Solicitation Addendum

Addendum No.: 3
Solicitation No.: 18-TA002593SR
Project No.: 404-6028386
Solicitation Title: Force Main 12A Replacement
Addendum Date: March 19, 2018
Procurement Contact: Stacia Raposa, stacia.raposa@mymanatee.org

MANATEE COUNTY PUBLIC WORKS DEPARTMENT		3/4" & 1" BACKFLOW PREVENTER	UW-12
REV. BY	DATE		
	DATE OF APPROVAL

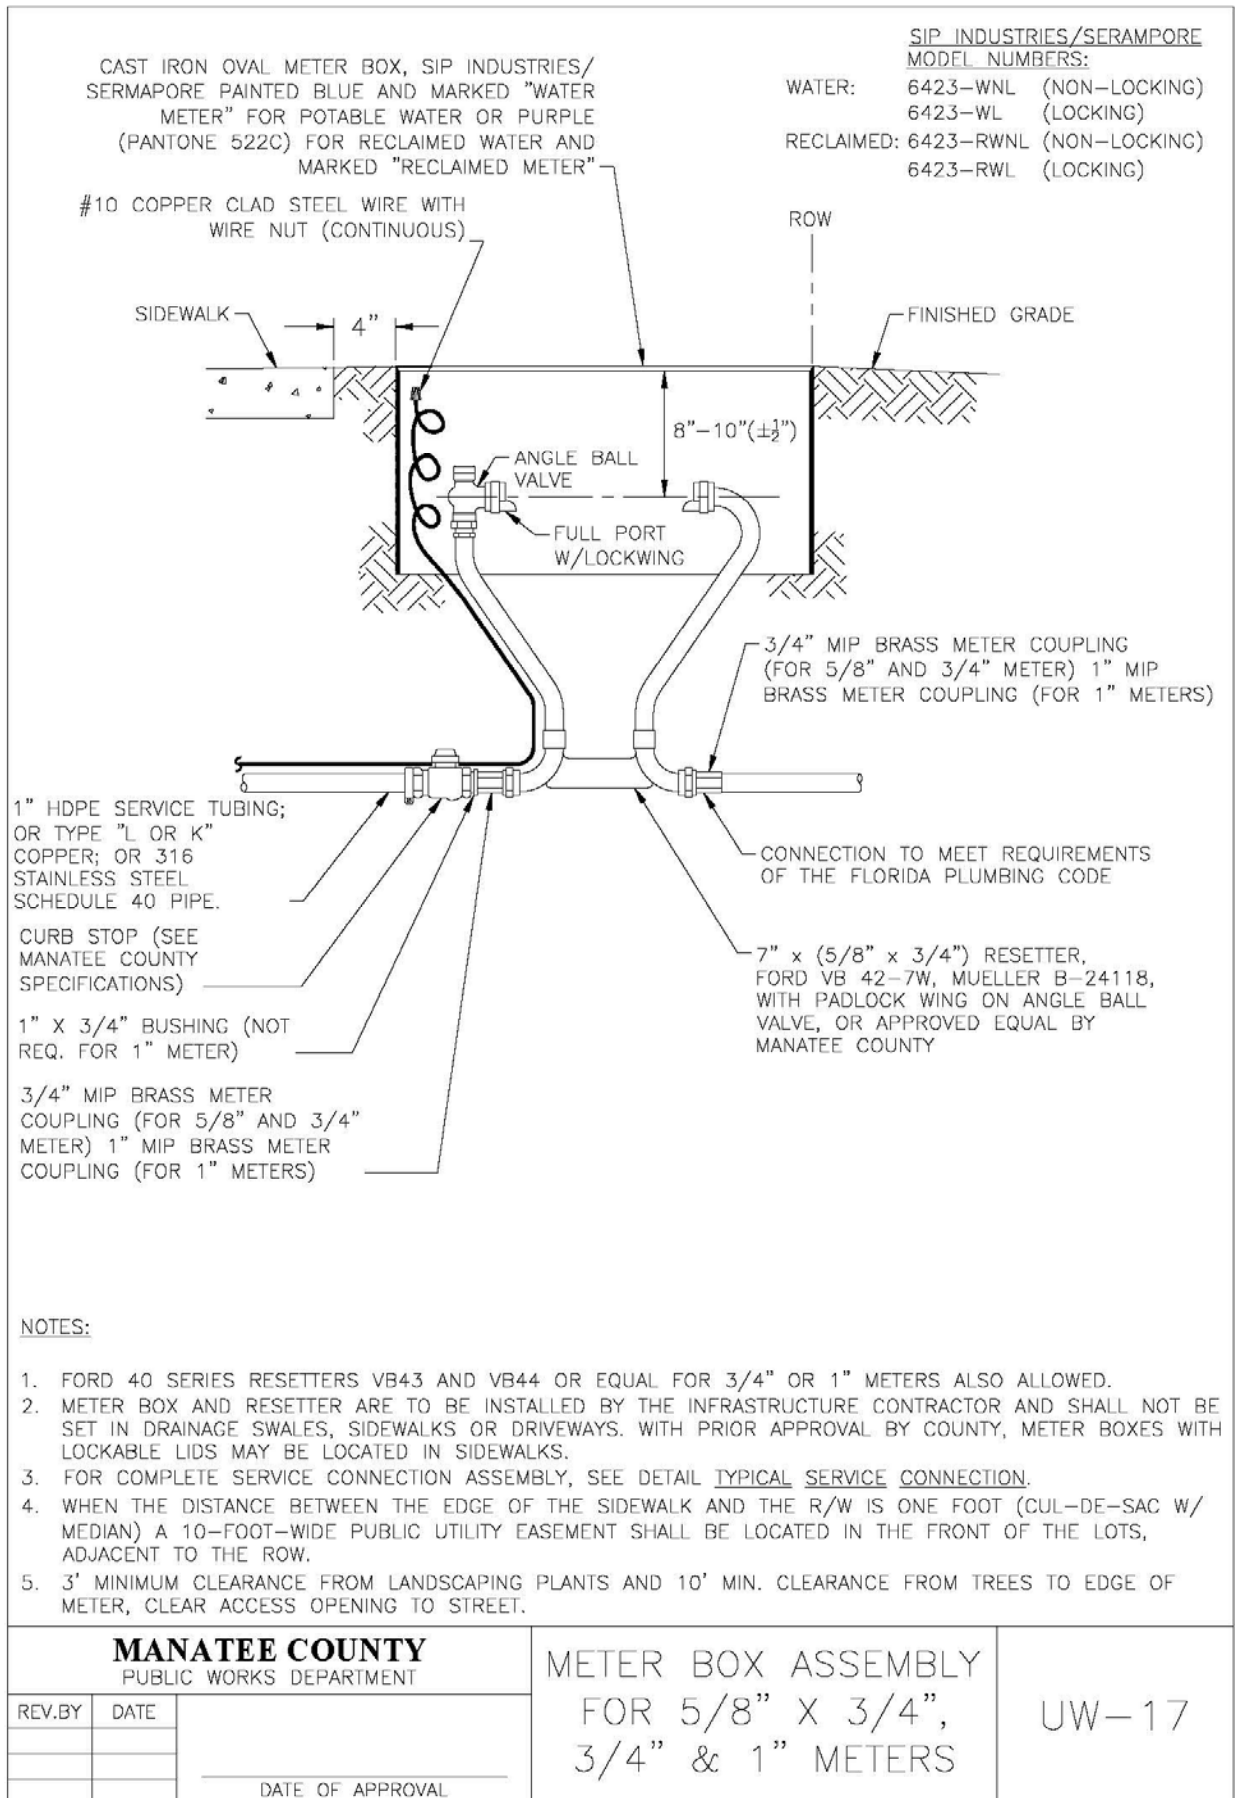
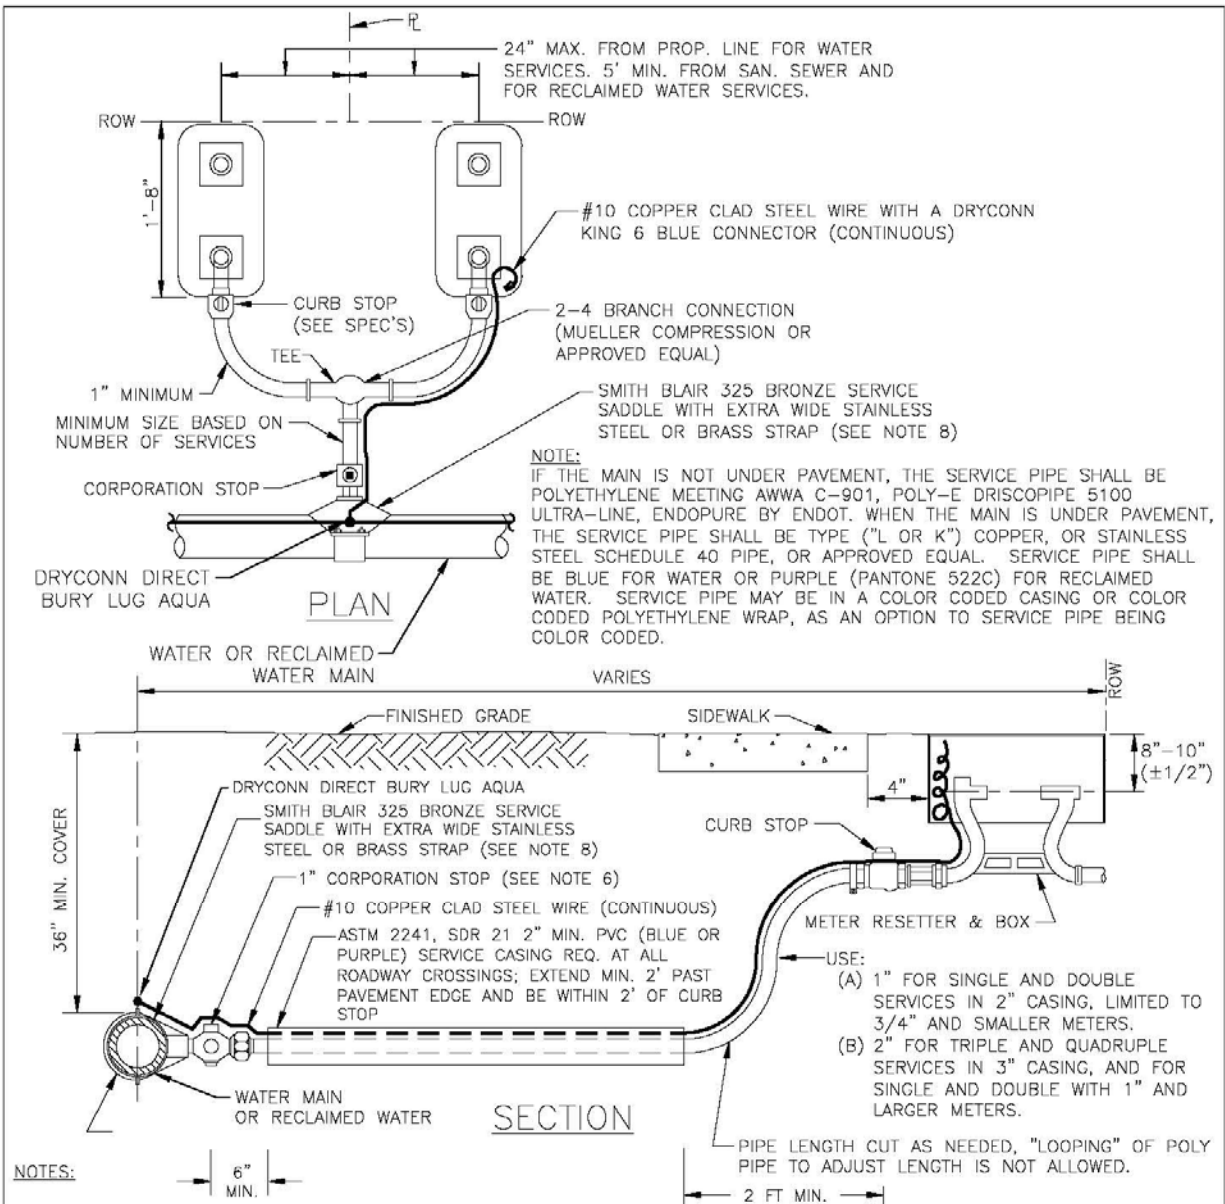
Add Details UW-12, UW-17, and UW-19 that are attached to this Addendum 3, which differ from current Utility Standards and supersede any copies on the original plan set.

Details UW-12, UW-17, and UW-19, that differ from the current Utility Standards, have been added to the plan set and supersede any copies on the original plan set.

R22. All service line replacements that move the meter or are performed on private property and require a plumbing permit shall require the installation of a backflow prevention assembly and vacuum breakers. The expansion tanks are no longer required and were removed from the bid documents by Addendum 1. The backflow prevention assembly shall have a pressure relief valve as per the updated Manatee County Detail UW-12 included with this Addendum 3.
